4 February 2022

Ref: L01/205550D/NB

NW Bicester – Response to Environment Agency Comments

Figure 1 – Comparison of the 0.1% Event with 25% Topsoil and Surface Water Flood Extent

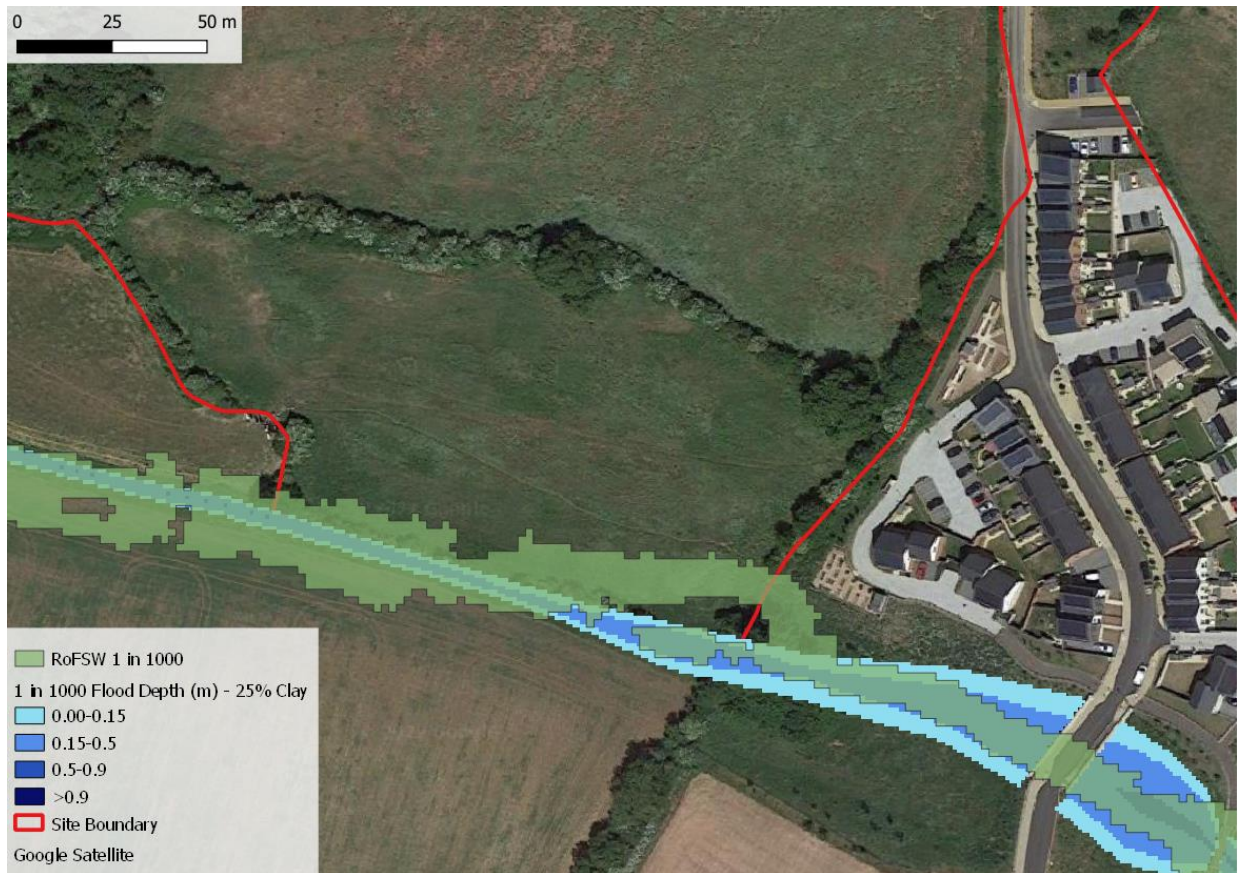
“In addition, the FRA advises that finished floor levels of all properties are set at least 150mm above existing ground level. While this should be sufficient if no development is proposed within areas of flood risk, we would advise as a precaution against any unpredicted flooding, finished floor levels of properties should be at least 300mm above the appropriate climate change flood level.”

The very conservative sensitivity test outlined above has not changed this conclusion. The resultant flood extent associated with a theoretical 25% clay topsoil coverage is still smaller than that defined by the two data sources identified above. This is shown in Figure 1 and 2.

Appendix B – Revised Flood Maps – Sensitivity Testing

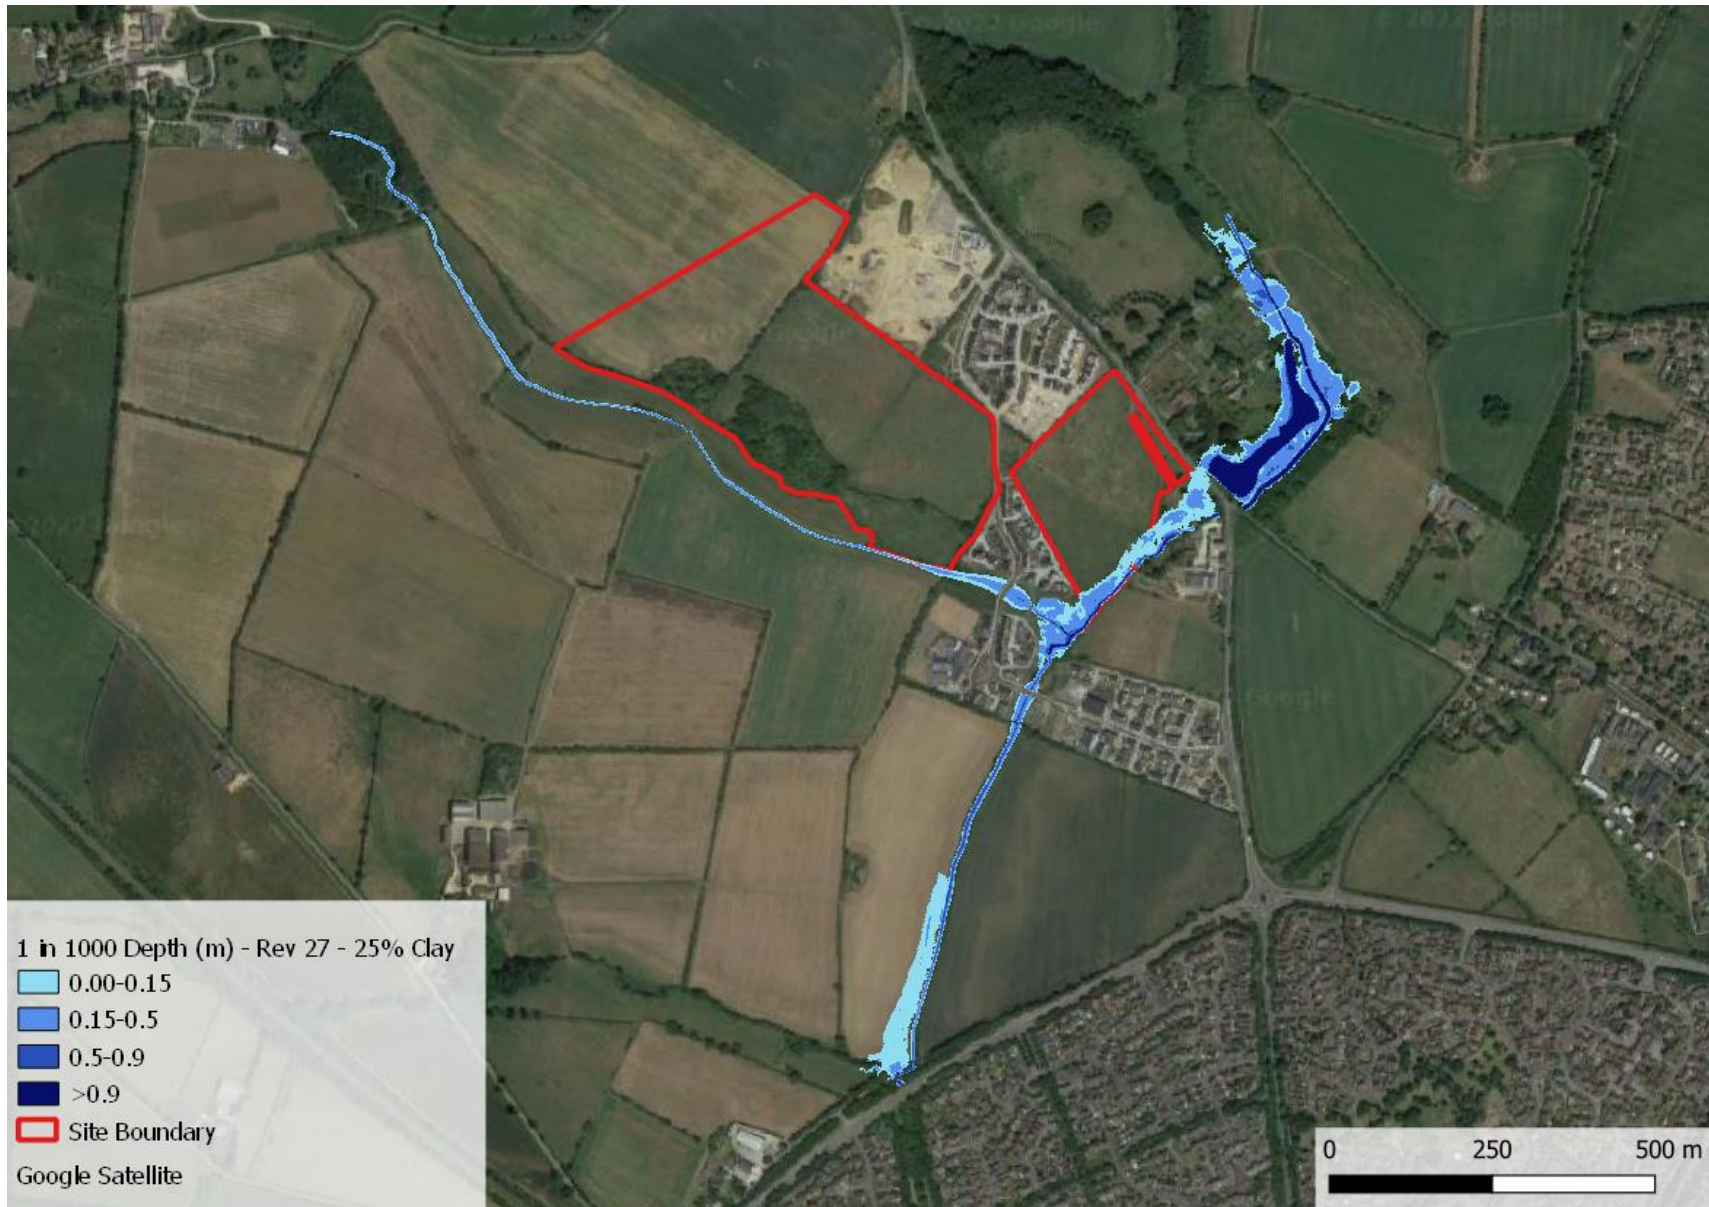
To test the impact of this potential uncertainty and demonstrate the robust nature of the model and parameters applied to the masterplan for the site, we have re-run the 0.1% annual probability event with both a 10% and 25% allowance of clay topsoil.

Whilst it was discovered that the flood extents for the 0.1% annual probability event have increased, this was not significant on site. The resultant flood maps are enclosed in Appendix B.

Appendix C – Opportunity and Constraints Plan

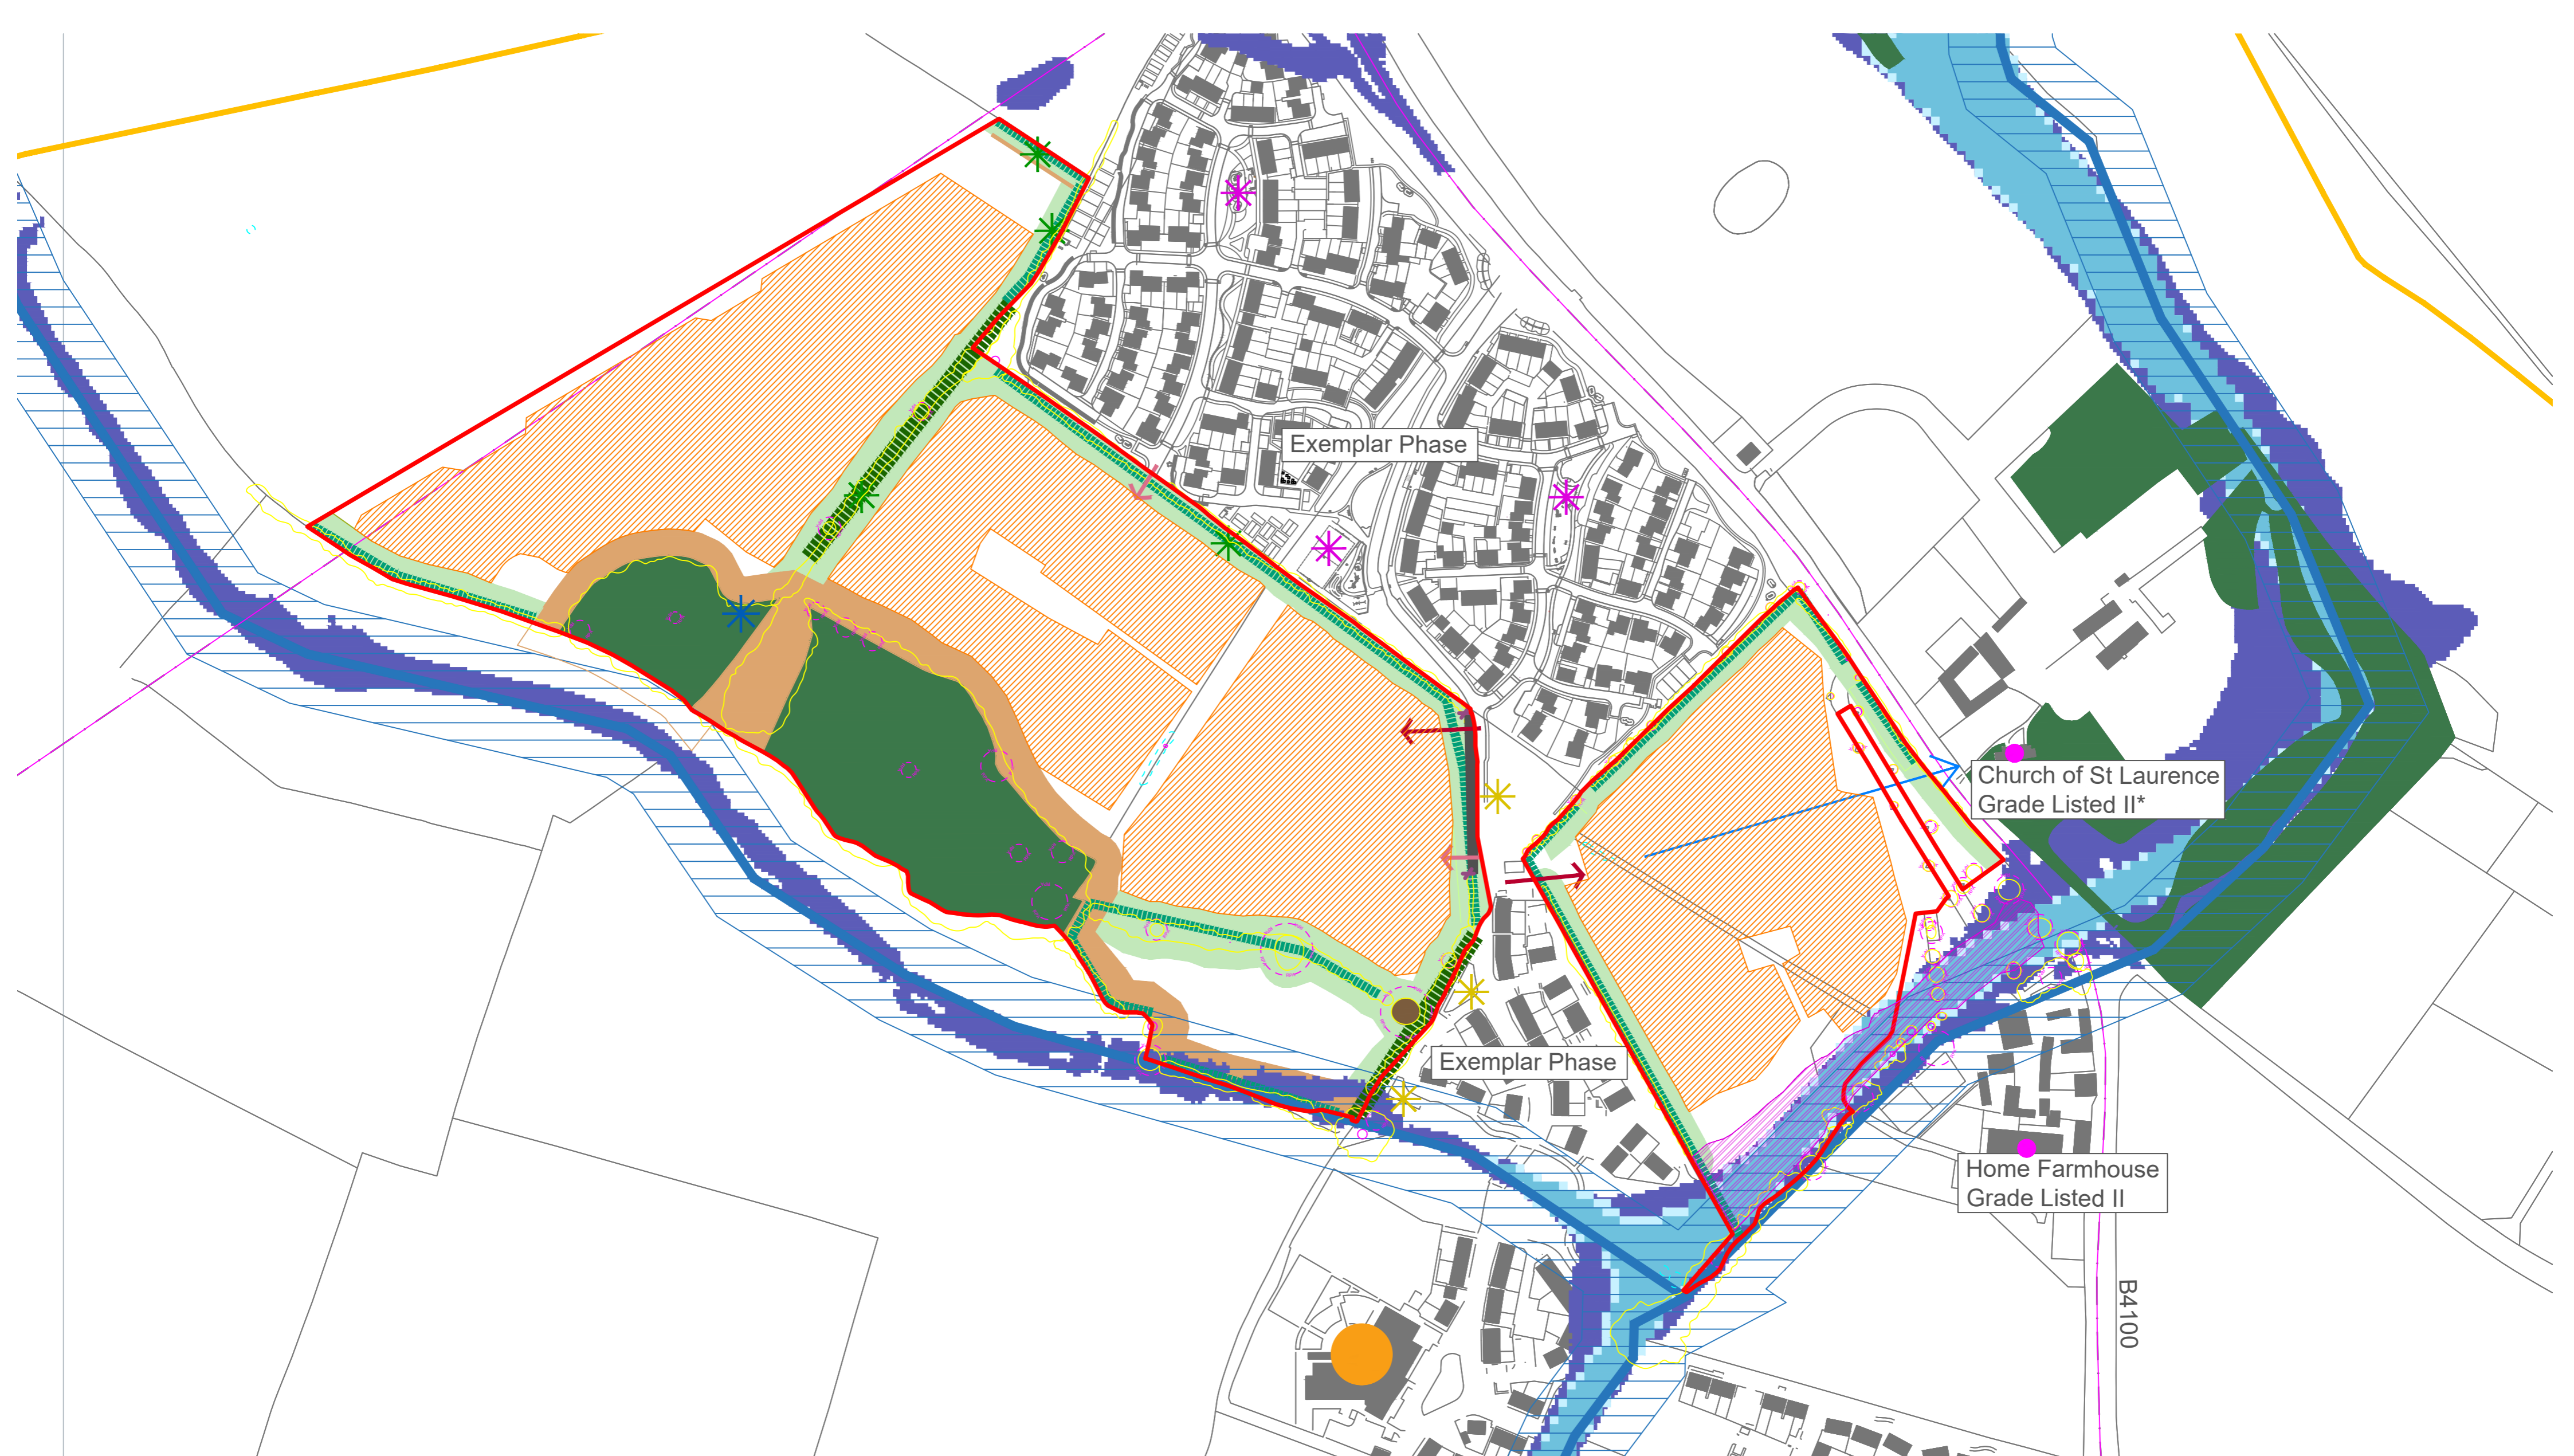
These layers were overlaid in the masterplanning process and are identified on the constraints and opportunities plan (see Appendix C). Therefore, all development (including SuDS) was steered out of the floodplain.
